**ADDENDUM 5**  
**Via E-Mail**  
**DATE: January 3, 2020**

Contract 18-C-00024 Howard F. Curren AWTP Junction Chamber No. 2 Sluice Gate Replacement

Bidders on the above referenced project are hereby notified that the following addendum is made to the Contract Documents. BIDS TO BE SUBMITTED SHALL CONFORM TO THIS NOTICE.

SHEET  
2

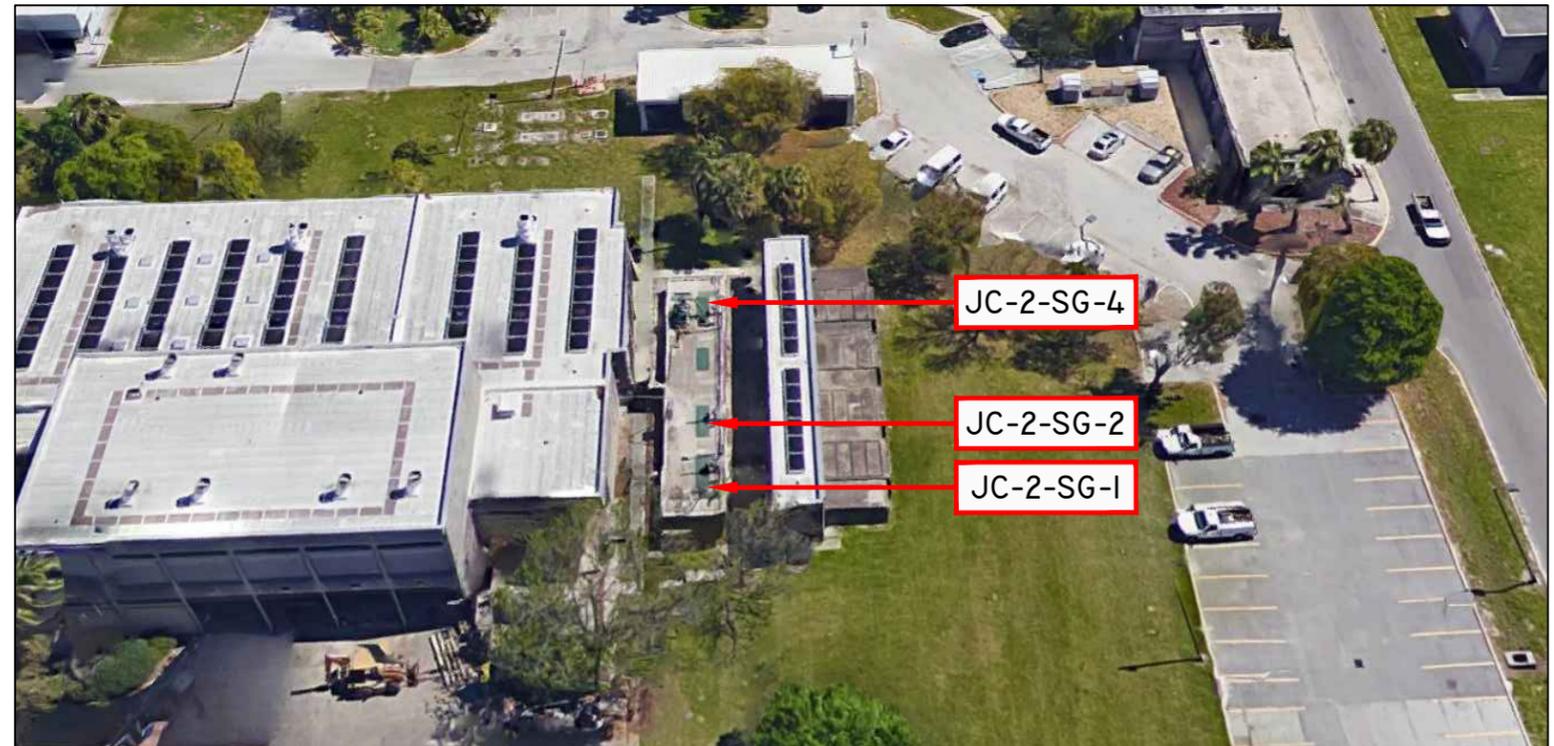
- △ G-8 CONTRACTOR SHALL REPLACE THE GASKETS FOR ALL DISASSEMBLED HARNESSTYPE COUPLINGS AND PIPES THAT ARE DESIGNATED TO BE REMOVED AND REPLACED. EXISTING HARDWARE SUCH AS NUTS AND BOLTS CAN BE REUSED. THE MANUFACTURER OF THE EXISTING HARNESSTYPE COUPLINGS IS UNKNOWN AND WILL NEED TO BE FIELD VERIFIED BY THE CONTRACTOR IN ADVANCE TO ORDER THE CORRECT GASKETS.

- △ G-9 AT LOCATIONS WHERE THE PROPOSED PIPING IS BEING CONNECTED TO AN EXISTING HARNESSTYPE COUPLING, THE PROPOSED PIPING SHALL BE FABRICATED WITH WELDED HARNESSTYPE LUGS AS SHOWN ON SHEET 16A. CONTRACTOR MUST FIELD VERIFY DIMENSIONS OF EXISTING COUPLING AND HARNESSTYPE LUG LOCATIONS BEFORE SUBMITTING FABRICATION DRAWINGS FOR REVIEW. EXISTING HARNESSTYPE TIE RODS CAN BE REUSED.

SHEET  
 9

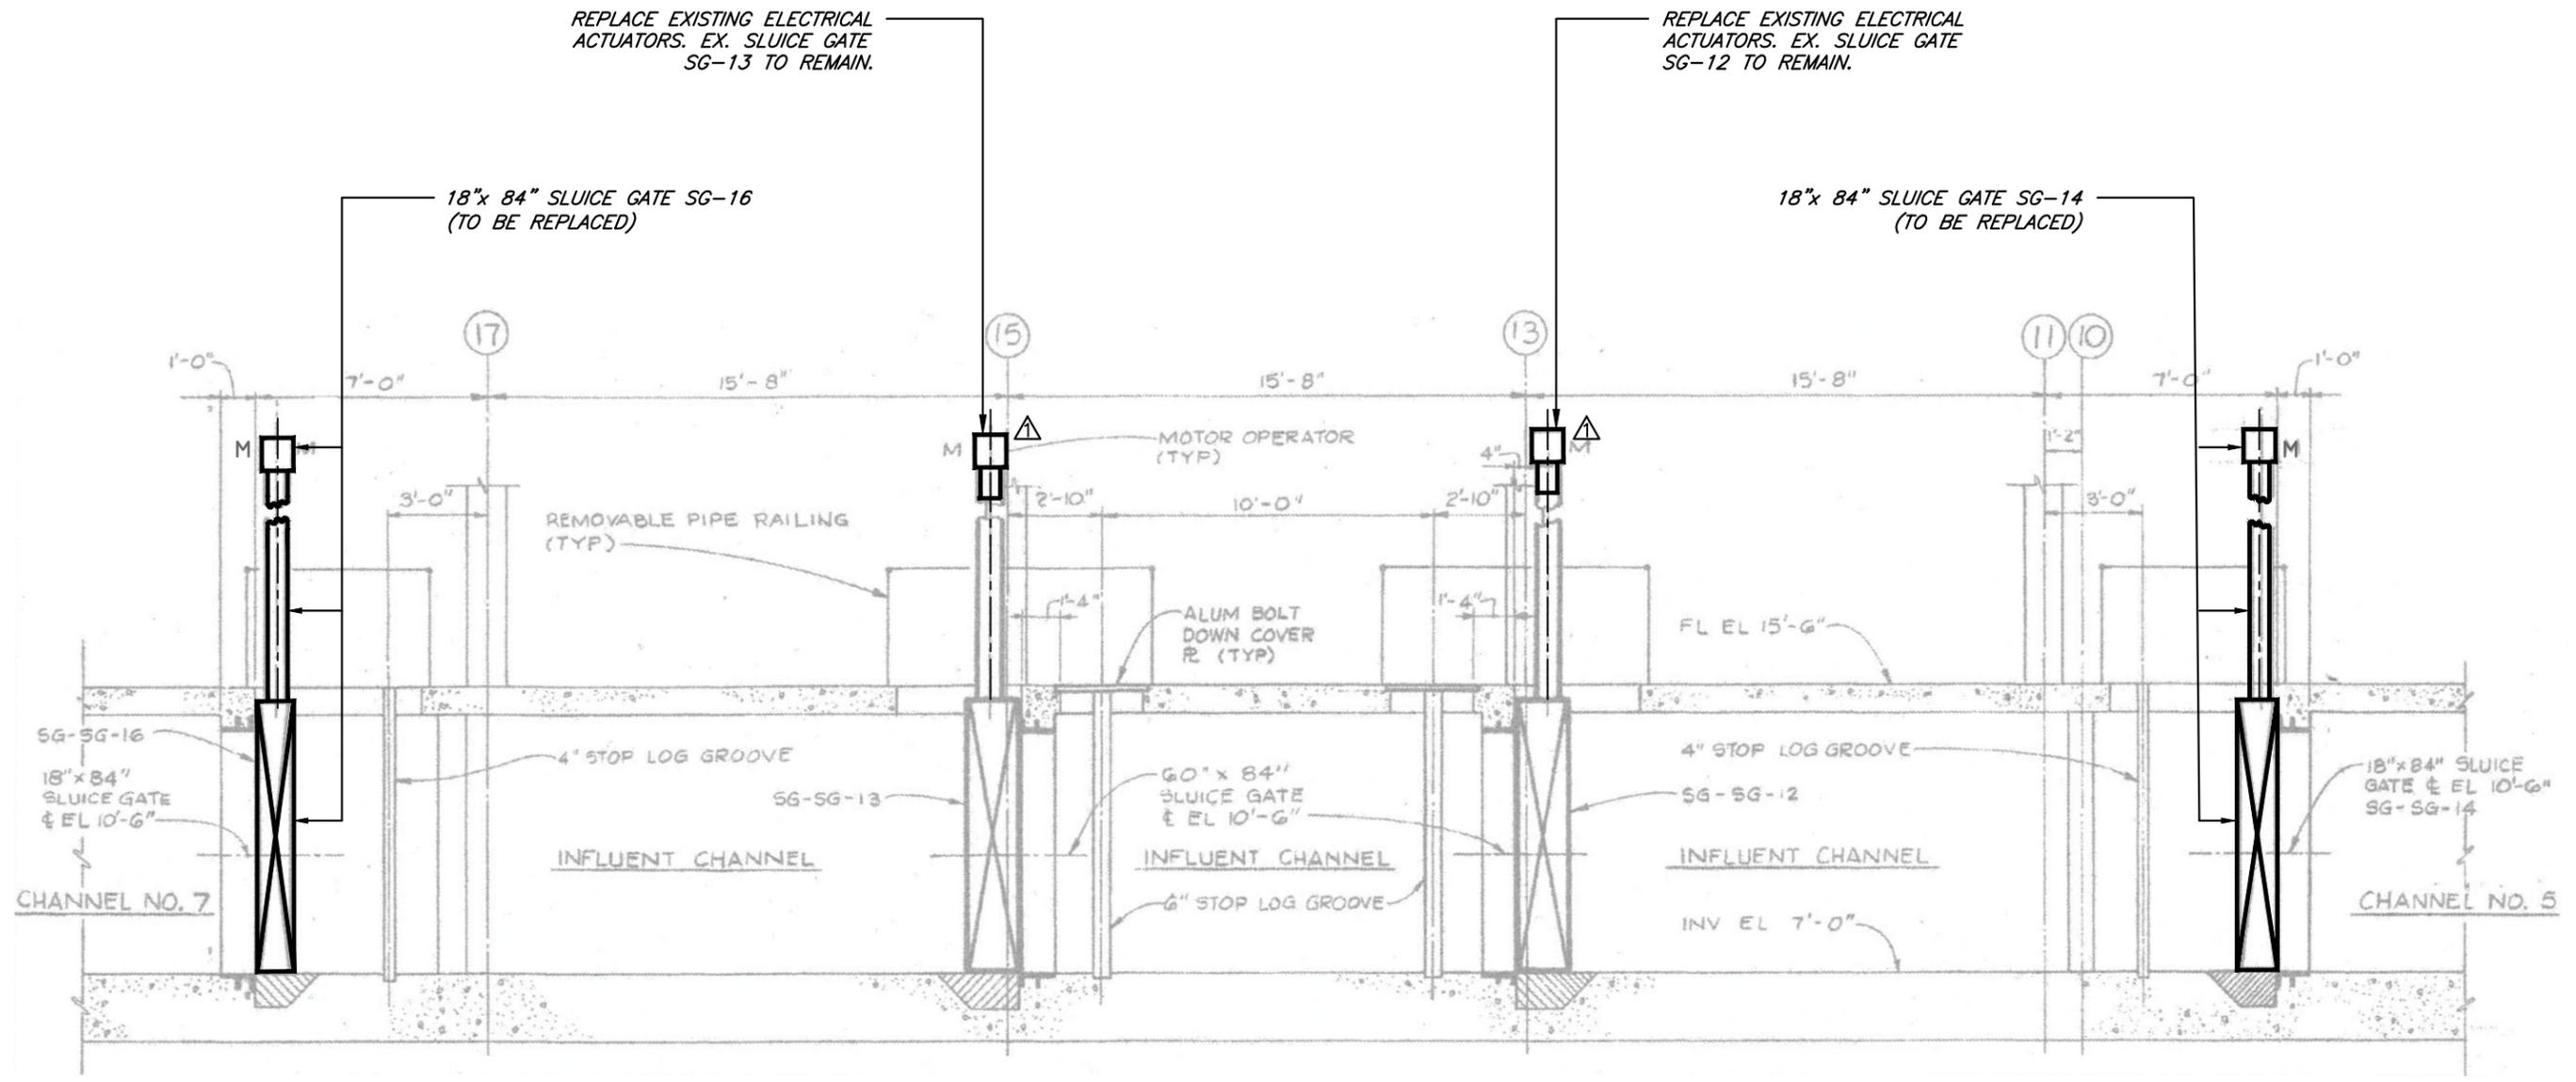
No.	DATE	REVISIONS
2		
△	12/18/19	ADDENDUM: ADDED TEMPORARY DEWATERING SYSTEM & ELECTRICAL ACTUATOR REPLACEMENT SG-12, SG-13

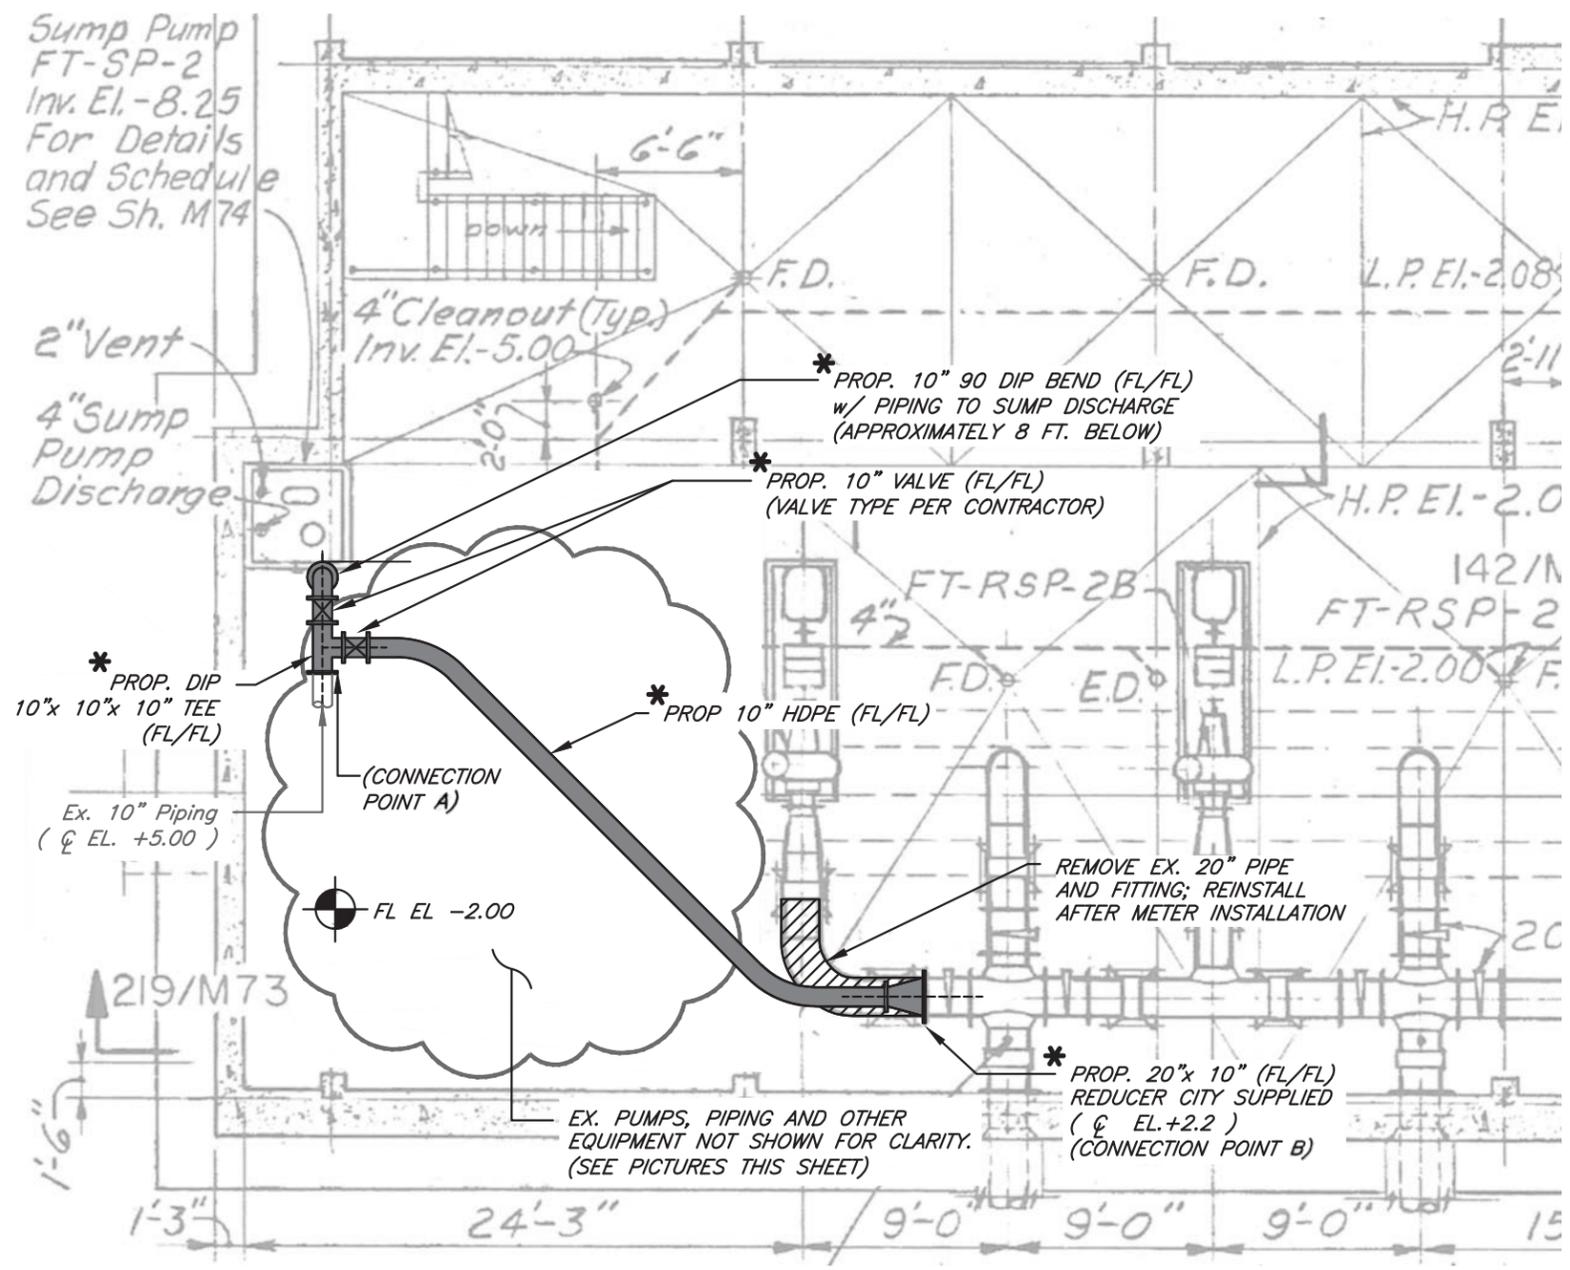
NOTE: BEFORE REMOVING PIPE SHOWN, CONTRACTOR MUST INSTALL TEMPORARY PIPING AS SHOWN ON SHEET 11C SO THAT PLANT OPERATIONS CAN DRAIN THE PIPES

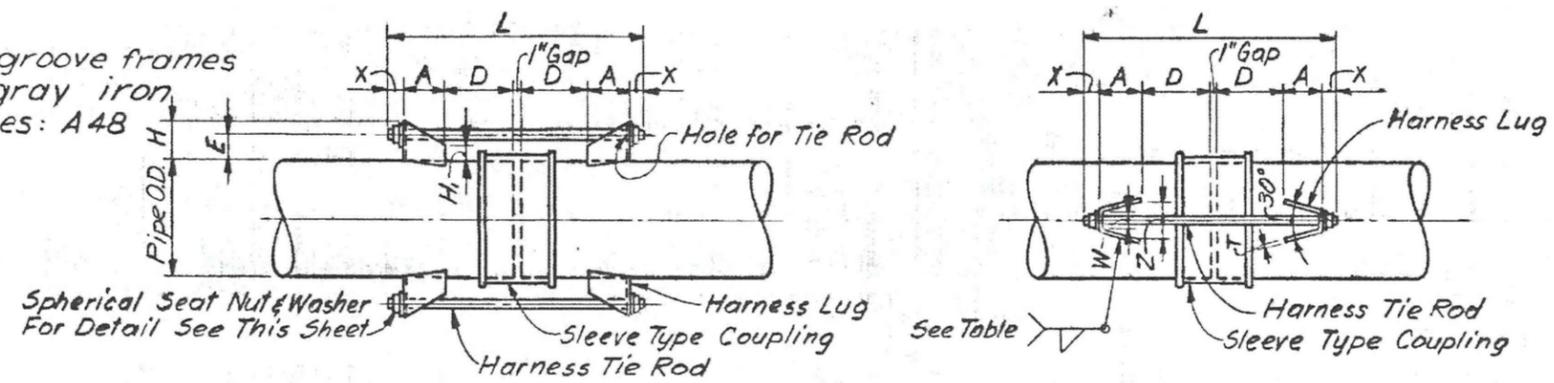
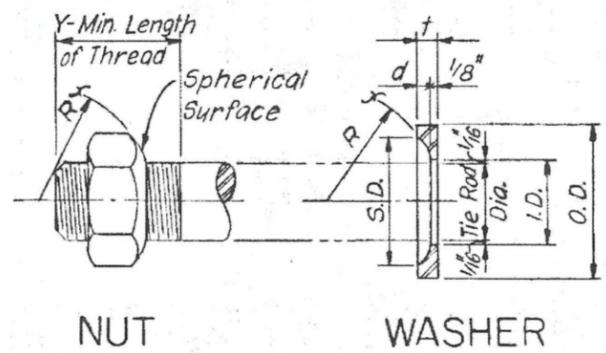
- G-5 ANY MODIFICATIONS TO THE EXISTING HARNESSTYPE STEEL COUPLINGS SUCH AS WELDING NEW HARNESSTYPE LUGS TO FABRICATE SECTIONS OF STEEL PIPE OR OTHER SIMILAR TYPE CHANGES SHALL BE IN ACCORDANCE WITH TYPE A HARNESSTYPE SLEEVE TYPE COUPLING DETAIL ON SHEET 16A
